IEC 60745-2-12

Edition 2.0 2008-05

AMENDMENT 1
AMENDEMENT 1

**Hand-held motor-operated electric tools – Safety –
Part 2-12: Particular requirements for concrete vibrators**

Figure 102 – Typical design b) of a concrete vibrator

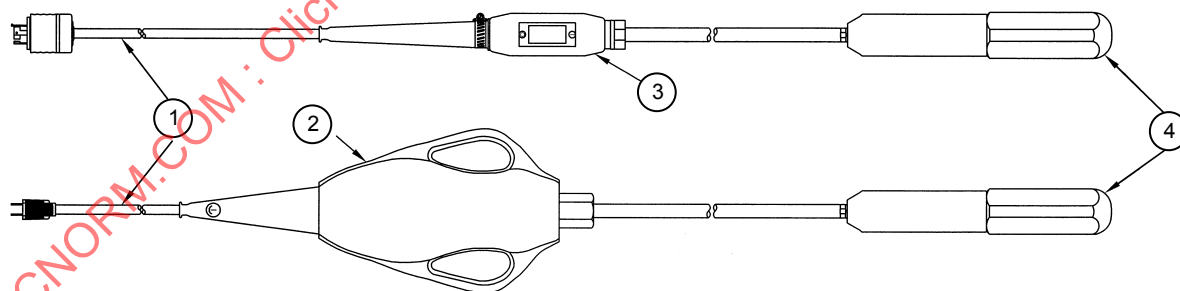
For design b) as defined in 3.101, the motor unit shall be IPX4.

- of at least 5 m for designs a) as defined in 3.101;
- of not more than 0,5 m or of at least 5 m for design b) as defined in 3.101.

Figure 101 – Typical design a) of a concrete vibrator

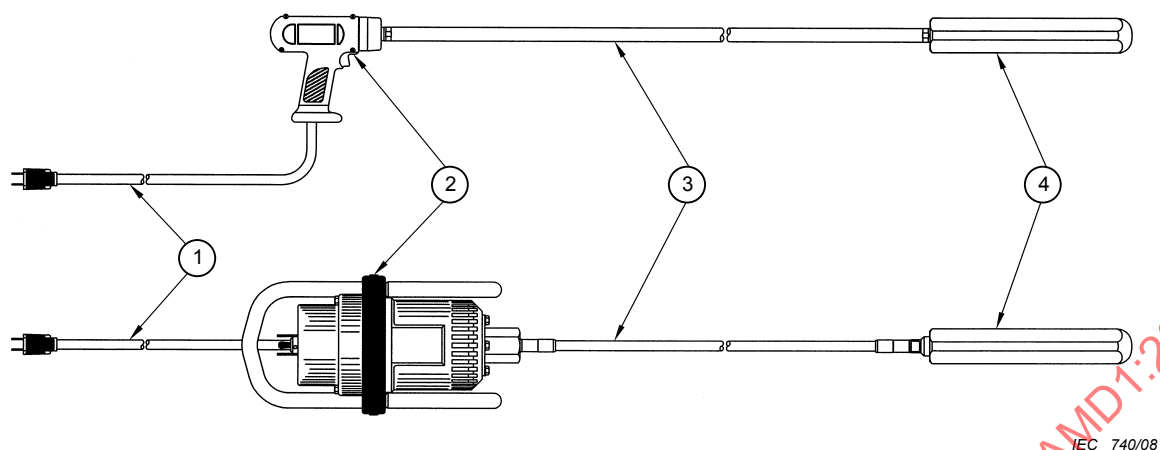
- a) the motor and the vibrating mechanism are inside the vibrator bottle to which the part containing the mains switch or a power converter and switch handle assembly is connected by means of a long flexible hose containing the interconnecting cable. The long flexible hose may be used as the handle (see Figure 101);
- b) only the vibrator mechanism is inside the vibrator bottle to which a separate portable unit, comprising the motor, the handle and the mains switch, is connected by means of a long flexible hose containing a flexible shaft (see Figure 102)

For design a) as defined in 3.101, the enclosure of all parts and the cable entry shall be IPX7.

24.101 The supply cable attached to the part containing the mains switch shall have a length:
